DALLAS-FORT WORTH
INTERNATIONAL AIRPORT

ADDENDUM NO. 06

Contract No. 9500414

DPS Fire Training Facility Upgrades

TYPICAL B747 AIRCRAFT MOCKUP

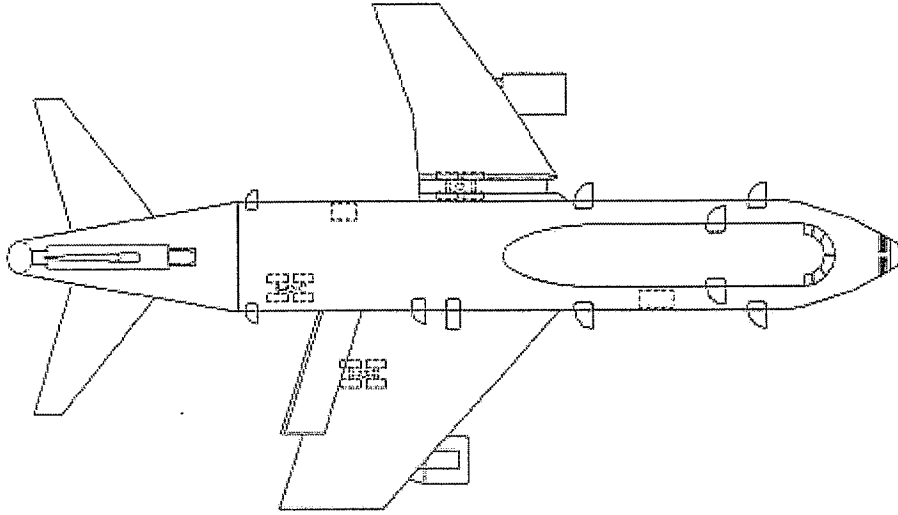
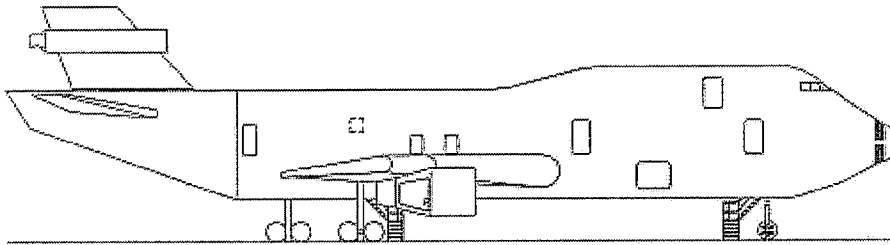
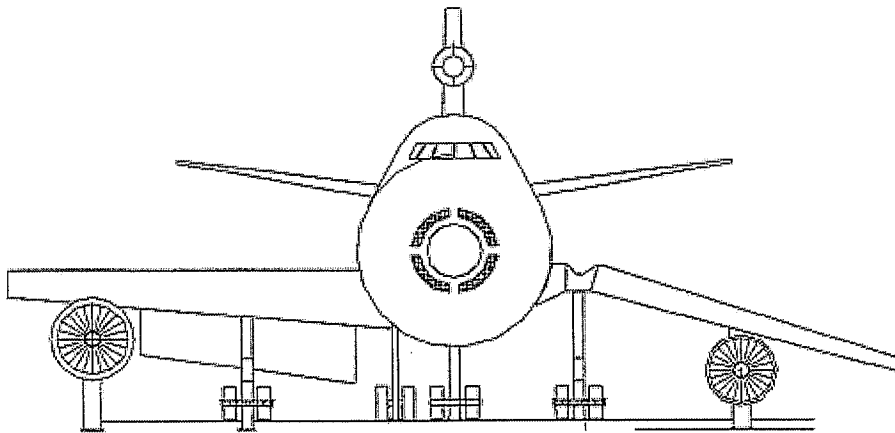
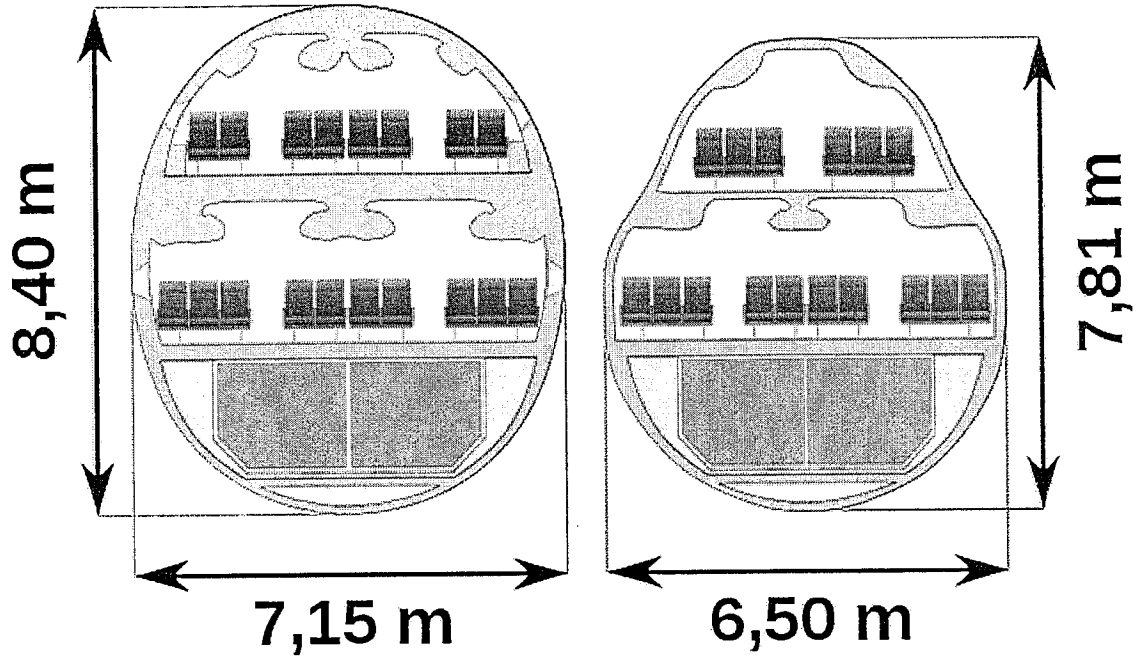
27. Addendum No. 4, Attachment, Section 01010, Paragraph 1.2, Item B(8), and B(4) – These items are “Add Alternate No. 2” and “Add Alternate No. 3” and require that the A380 and B747 mockups be modified to comply with Advisory Circular 150/5220-17B. This circular requires that for ARFF index C-E airports the mockup length be at least 75 ft and that the wing span (measured to centerline of mockup) be at least 30 ft. The mockup

length and the wing span do not appear to be consistent with the intent of providing a wide body mockup. Given the size of the existing burn pit, would the Owner consider modifying the specification to require that the B747 and A380 mockup length be 150 feet in length and that the wing span be a minimal 50 ft in length as measured from the centerline of the mockup?

28. Addendum No. 4, Attachment, Section 01010, Paragraph 1.2, Item B(8), and B(4) – No detailed requirements are provided for the B747 and A380 mockups other than referencing the FAA Advisory Circular which only provides minimal overall shell or exterior dimensional requirements. In order to provide a responsive price, could you provide more detailed requirements for the interior configuration and features for each mockup? The following attachments 1 and 2 to these clarification questions, for example, provide a sample of the type of feature requirements that affect pricing and need to be defined.

Response: Section 01010 has been revised to reflect additional requirements for the proposed mock-ups. The desired length of the mockups for Add Alternates No. 2 and 3 is 150', with a wing span of 50' measured from the centerline of the mockup.

Response: Section 01010 has been revised to include additional requirements
